UNITED STATES PATENT AND TRADEMARK OFFICE

APPLICATION NO.	FILING DATE	FIRST NAMED INVENTOR	ATTORNEY DOCKET NO.	CONFIRMATION NO.
09/897,779	06/29/2001	Zine Eddine Boutaghou	1734.001US1	9826

Office Action Summary

Fig. 18

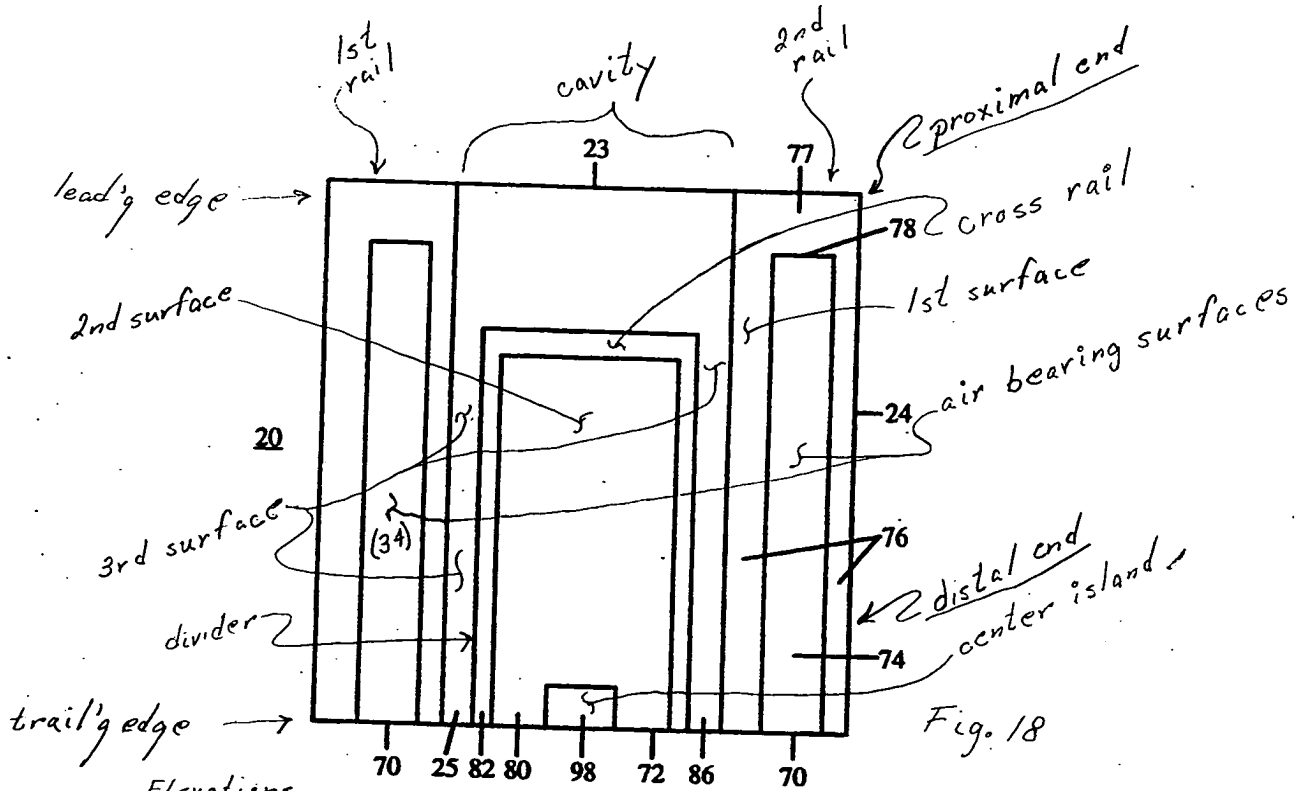
See Fig. 7B and Fig. 18 with Fig. 7B being illustrative of the elevations of the different surfaces of the bottom face of the slider relative to the top surface of the slider.
